**Permit Application Review Report**  
**Date: 7/9/2025**

**Project Name:** Lakeview at Sloth Farms

**Project PAN:** P-24-039

**Project Purpose:** 5 lot residential subdivision and associated stormwater treatment

Figure 2: Site Plan

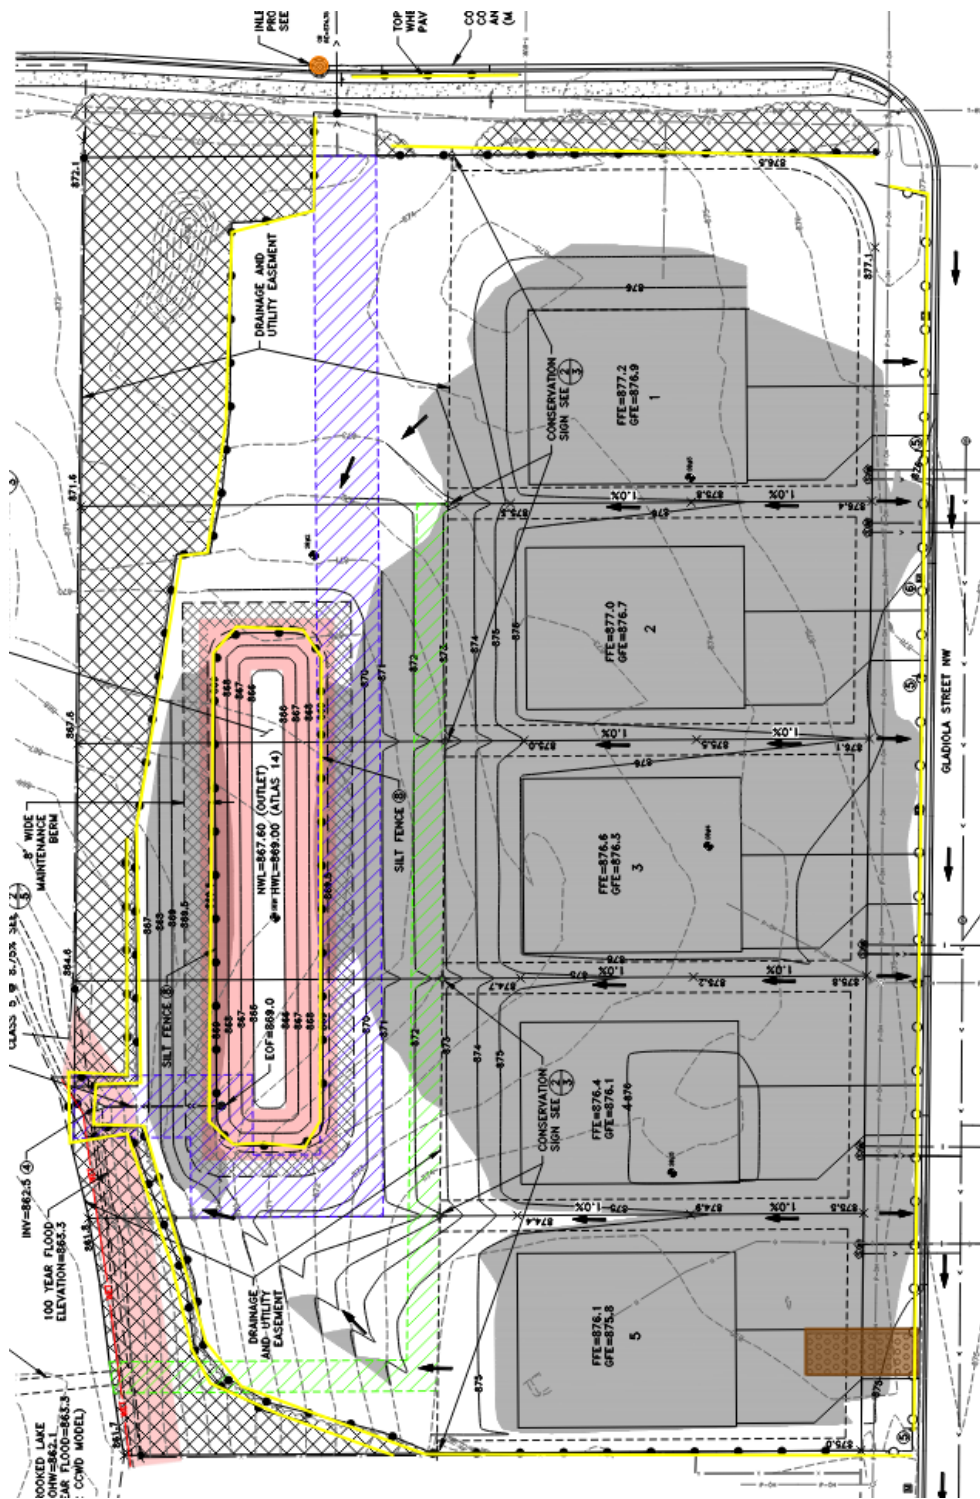
Rate Control: Peak stormwater flow rate at the Gladiola St discharge point increases from the pre-development condition for the 24-hour precipitation event with a return frequency of 2-, 10-, 100-years as shown in Table 1. The project will not impact Drainage Sensitive Use areas. The rate control standard is not met, however, the City of Andover has reviewed and approved this rate increase as it goes to City storm sewer.

The volume control standard has been met to the maximum extent practicable as shown in Table 2. The reconstructed impervious of Gladiola St is lower than the project site and cannot be raised for treatment. Area A3P cannot be treated because routing the area back on site is not feasible due to existing grades and space constraints.

The TSS removal standard is not met at each discharge point as shown in Table 4, however, complete treatment is not feasible as explained in the volume management section.

A continuous buffer is proposed on the plans; but it is identified as temporary. Because the resource is a Public Water, the average buffer width must be 50 ft, with a minimum width of 30 ft and a maximum width of 100 ft. Total buffer area required is 5,800 square feet. Total buffer area provided is 2,200 square feet, which does not meet the requirement. Permanent monumentation at each parcel line is not required because conservation easement signs are proposed that cover the entire required buffer area.

3. Provide a permanent vegetated buffer along Crooked Lake that is an average of 50 feet from the OHWL. Monumentation signs will not be required because the conservation easement signs cover the entire buffer area.
